REVISED RESPONSE TO REQUEST FOR ADDITIONAL INFORMATION

APR1400 Design Certification

Docket No. 52-046

RAI No.: 182-8160
SRP Section: 03.07.01 – Seismic Design Parameters
Application Section: 3.7.1
Date of RAI Issue: 08/31/2015

Figure 1. Comparison between APR1400 HRHF PSD, Target PSD and SRP 3.7.1 Rev. 4 CEUS rock target PSDs for H1H component

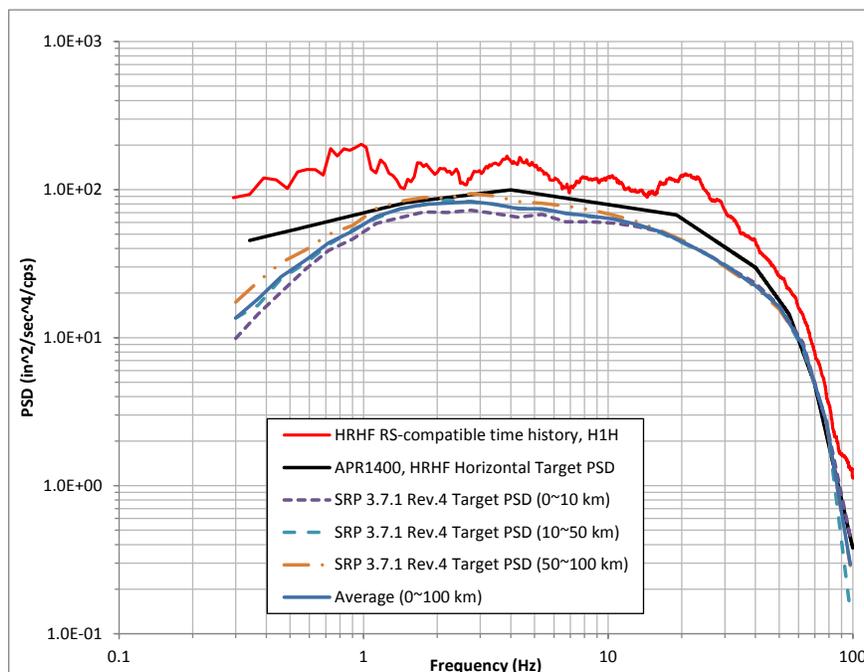
Technical report APR1400-E-S-NR-14004-P, Rev. 1 states that the APR1400 HRHF RS-compatible target PSDs were developed in the frequency range of 0.3 Hz to 80 Hz. It is understood that 0.3 Hz is consistent with Appendices A and B of SRP 3.7.1; however, the report does not provide a basis for the choice of 80 Hz. It is recently recognized during the development of Appendix B of SRP 3.7.1 Rev. 4 that the upper bound frequency in the PSD assessment should be consistent with the DRS shape. For a DRS with a zero period acceleration (ZPA) frequency, the ZPA frequency can be used as the upper bound frequency for the development of the target PSD. However, the horizontal and vertical HRHF DRS do not exhibit a definitive ZPA (zero period acceleration) frequency. As such, the applicant is requested to justify the use of 80 Hz as the upper bound frequency for the development of target PSDs.

The comparison between the HRHF horizontal time history PSD for the H1H component and PSD given in Appendix B of SRP 3.7.1 Rev. 4 is shown in Figure 1, which shows that the APR1400 HRHF time history PSD envelope the PSD given in Appendix B of SRP 3.7.1 Rev. 4.

Figure 3-11 Smoothed Ensemble-Mean PSD and Piecewise Log-Log Linear PSD Obtained from Generated 30 Time History Ensemble

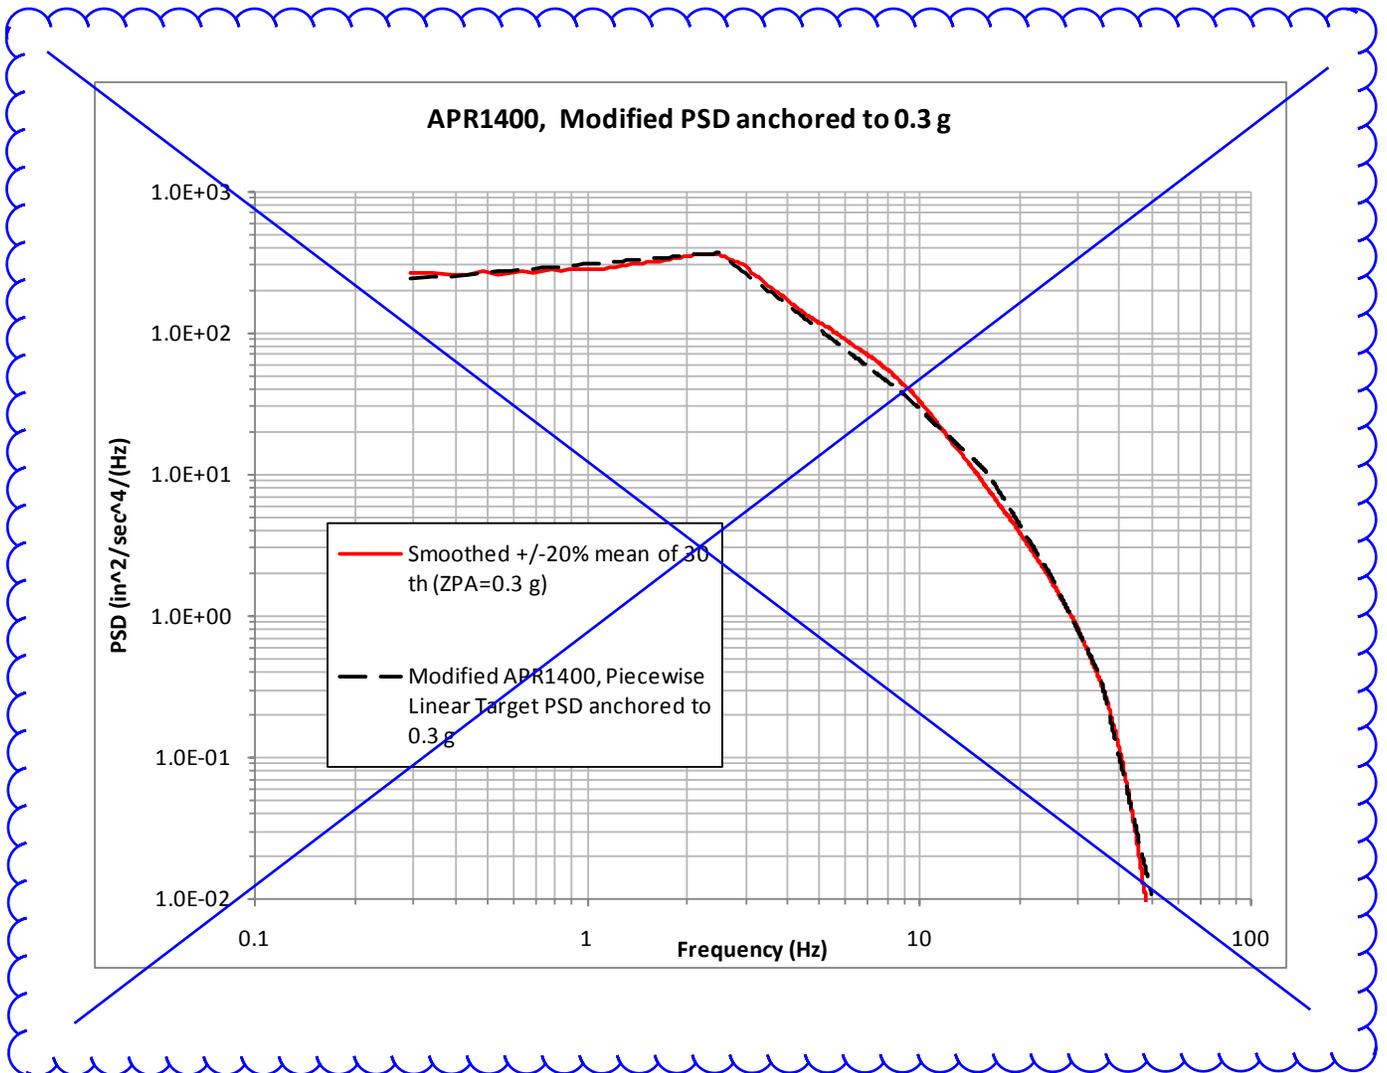
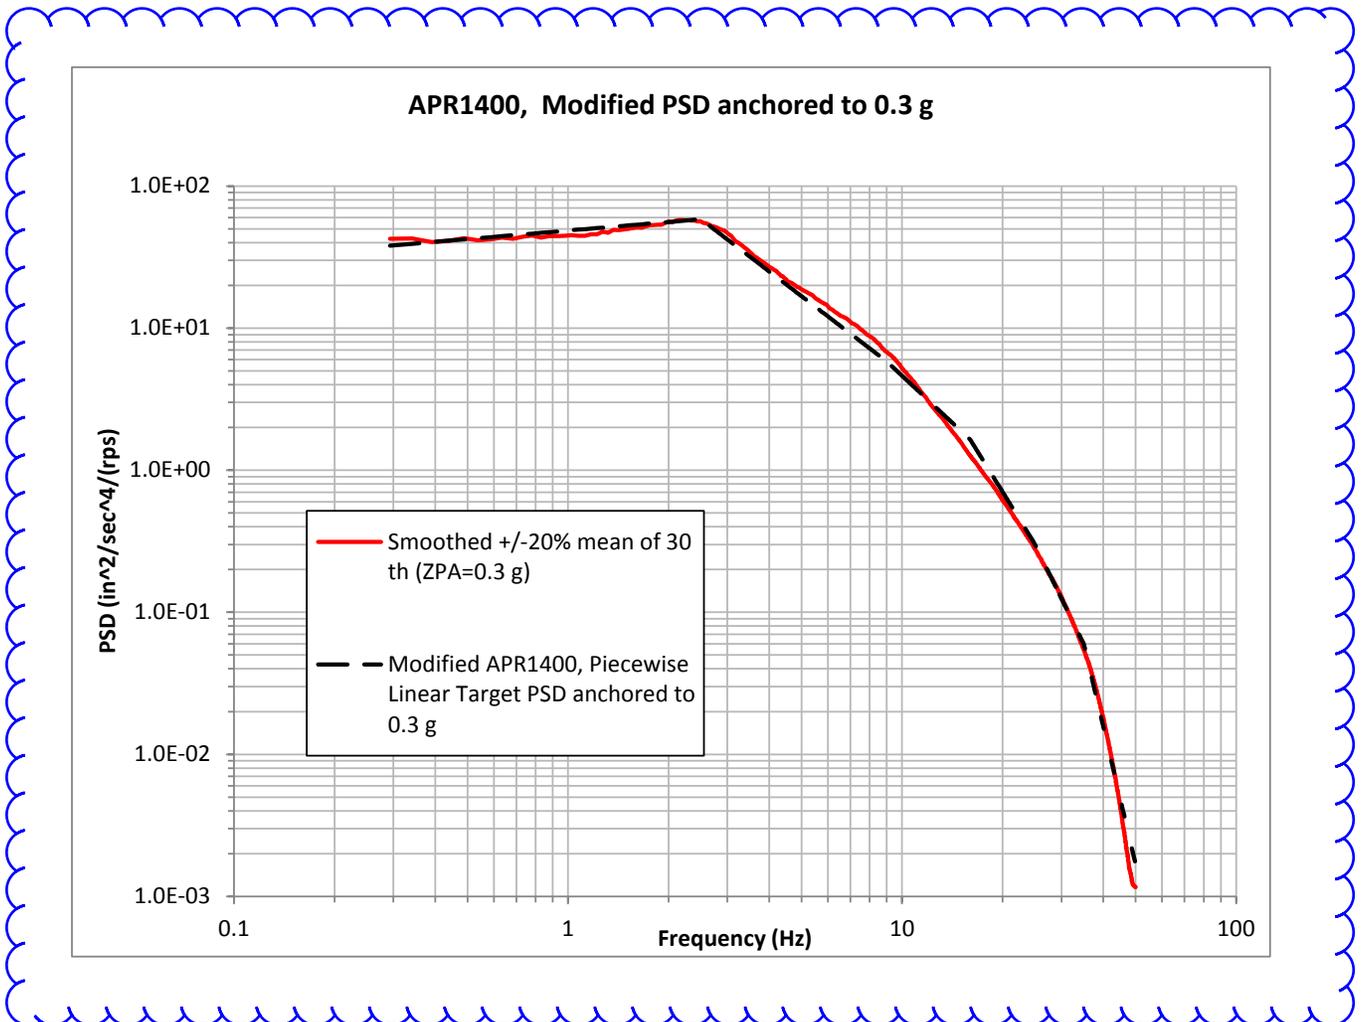
Figure 3-11 of APR1400-E-S-NR-14001-P, Rev. 0, "Seismic Design Bases" shows the smoothed ensemble-mean PSD and the piece-wise log-log linear PSD from the 30 time histories, and Figure 3-12 shows the target PSD and the minimum required PSD. Both figures are for the horizontal CSDRS anchored at 0.3 g. However, the PSD functions shown in Figure 3-11 differ significantly from Figure 3-12 (and other PSD figures after Figure 3-12). The applicant is requested to justify this difference.

- (c) The new vertical target PSD will be developed using 30 simulated time histories, and the results will be provided by **June 30, 2016**.
- (d) A PSD function is plotted in the unit of power (in^2/sec^4) per unit frequency. If the frequency is in Hz (cycle/sec) unit, then the PSD unit is ($\text{in}^2/\text{sec}^4/\text{Hz}$). If the frequency is in rps (radian per sec) unit, then the PSD unit is ($\text{in}^2/\text{sec}^4/\text{rps}$). Since $\omega = 2\pi f$, where f is frequency in Hz and ω is frequency in rps. Thus, the PSD **value** in the unit of ($\text{in}^2/\text{sec}^4/\text{Hz}$) unit is equal to 2π times the PSD **value** in the unit of ($\text{in}^2/\text{sec}^4/\text{rps}$), i.e., $(\text{in}^2/\text{sec}^4/\text{Hz}) = (\text{in}^2/\text{sec}^4/\text{rps}) \div 2\pi$.

The PSD in Figure 3-11 is plotted in the unit of ($\text{in}^2/\text{sec}^4/\text{Hz}$). The PSD in Figure 3-12 (and other PSD figures after Figure 3-12) is plotted in the unit of ($\text{in}^2/\text{sec}^4/\text{rps}$). The PSD in Figure 3-12 multiplied by a factor of 2π will give the numerical value of the PSD in the same unit of PSD in Figure 3-11. The use of the unit of ($\text{in}^2/\text{sec}^4/\text{Hz}$) is convenient for comparison with the target PSD compatible with the target PSD for the RG 1.60 horizontal spectra. The use of the unit of ($\text{in}^2/\text{sec}^4/\text{rps}$) is convenient for checking compatibility with the time history PSD, which is computed from the Fourier spectrum in the frequency unit of rps.

Figure 3-11 of technical report APR1400-E-S-NR-14001-P/NP, Rev. 0 will be revised.
